Project	<b>IEEE 802.16 Broadband Wireless Access Working Group</b> < <a href="http://ieee802.org/16">http://ieee802.org/16</a> >	
Title	<b>DL-MAP and UL-MAP CID Table IEs</b>	
Date Submitted	<b>2005-01-26</b>	
	Mary Chion Sean Cai Jason Hou Jing Wang Dazi Feng Jun Han Irving Wang	<a href="mailto:mchion@ztesandiego.com">mchion@ztesandiego.com</a> <a href="mailto:scai@ztesandiego.com">scai@ztesandiego.com</a> <a href="mailto:jhou@ztesandiego.com">jhou@ztesandiego.com</a>
	ZTE San Diego Inc. 10105 Pacific Heights Blvd. San Diego, CA 92121 USA	Voice: 858-554-0387 Fax: 858-554-0894
Re:	Response to Sponsor Ballot on IEEE802.16e/D5a document	
Abstract	The proposed DL-MAP and UL-MAP CID table IEs can be used to not only improve DL subframe efficiency but also significantly reduce unnecessary power consumption.	
Purpose	To incorporate the text changes proposed in this contribution into the 802.16e/D6 draft.

# DL-MAP and UL-MAP CID Table IEs

**Figure 208c. Association for DL-MAP CID Records and DL/UL MAP Data Burst Allocation**

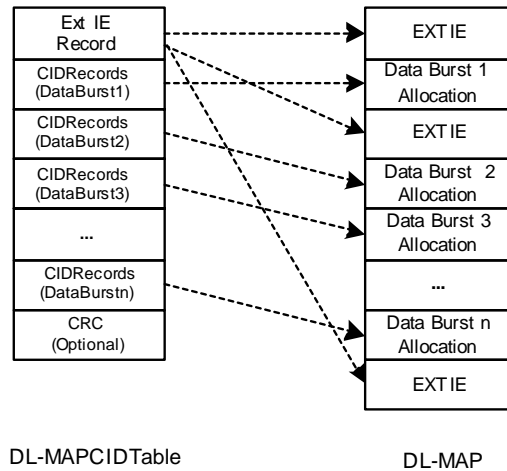
#### 8.4.5.3.20 DL-MAP CID table IE

The association of DL-MAP CID table IE records and DL\_MAP allocations are shown in Figure 208c.

**Table 284k—DL-MAP CID Table IE**

<b>Syntax</b>	<b>Size</b>	<b>Notes</b>
<u>DL-MAP CID table IE () {</u>		
<u>Extended DIUC</u>	<u>4 bits</u>	<u>0x??</u>
<u>Length</u>	<u>4 bits</u>	<u>Length in bytes of following fields</u>
<u>CID Table Sequence</u>	<u>2 bits</u>	<u>00: First page</u> <u>01: Middle page</u> <u>10: Last page</u> <u>11: Single Page</u>
<u>If ("CID Table Sequence" = "00")</u>		
<u>{</u>		
<u>  CID Format</u>	<u>2 bits</u>	<u>00: 16 bits</u> <u>01: 12 bits LSB</u> <u>10: 8 bits LSB</u> <u>11: 4 bits LSB</u>
<u>  H-ARQ MAP INC</u>	<u>1 bits</u>	<u>0: H-ARQ MAP Pointer IE not included in DL_MAP</u> <u>1: H-ARQ MAP Pointer IE included In DL_MAP</u>
<u>  MBS MAP INC</u>	<u>1 bits</u>	<u>0: MBS Service MAP IE not included in DL_MAP</u> <u>1: MBA Service MAP IE included in DL_MAP</u>
<u>}</u>		
<u>Begin CID records</u>		<u>Each CID record contains the list of CIDs. Two types of CID records:</u> <u>Normal CID Record: Each normal CID record contains a list of CID that is corresponding to a allocated data burst in DL_MAP</u> <u>Extended CID Record: Only one extended CID record, it contains the all CIDs that can be</u>

<u>included in extended IE.</u>
<u>for (i=0; i&lt;n; i++)</u>		<u>0 to n records can be included in a DL_MAP_CID Table IE. n doesn't need to be defined, it can be deducted based on length field</u>
<u>{</u>		
<u>  Broadcast Burst</u>	<u>1 bit</u>	<u>0: not a broadcast burst 1: broadcast burst</u>
<u>  If ( Broadcast Burst = 0 )</u>		<u>Number of CIDs left from the last CID Table</u>
<u>  {</u>		
<u>    Record Type</u>	<u>1 bit</u>	<u>0: Normal CID Record 1: Extended IE CID Record</u>
<u>    Continuation Flag</u>	<u>1 bit</u>	<u>0: This record will not be continued 1: This record will be continued in the first record of next IE</u>
<u>    NUM CIDs</u>	<u>6 bits</u>	<u>Number of CIDs in this record</u>
<u>    for (i=0; j &lt; NUM CIDs; j++)</u>		
<u>    {</u>		
<u>      CID</u>	<u>N bits</u>	<u>N = 16 when "CID Format" = "00" N = 12 when "CID Format" = "01" N = 8 when "CID Format" = "10" N = 6 when "CID Format" = "11"</u>

<u>    } //end for-loop NUM CIDs</u>		
<u>  } //if !broadcast burst</u>		
<u>}</u>		
<u>If ("CID Table Sequence" = "10" or = "11")</u>		
<u>{</u>		
<u>  CRC INC</u>	<u>1</u>	<u>0: CRC is not included 1: CRC is included</u>
<u>  CRC</u>	<u>32 bits</u>	<u>CRC-32 calculation for the DL-MAP CID Table IE (including all pages) is the same as that used for standard MAC messages</u>
<u>}</u>		
<u>Padding bits</u>	<u>Variable</u>	<u>Set to zeros to align octet boundary</u>
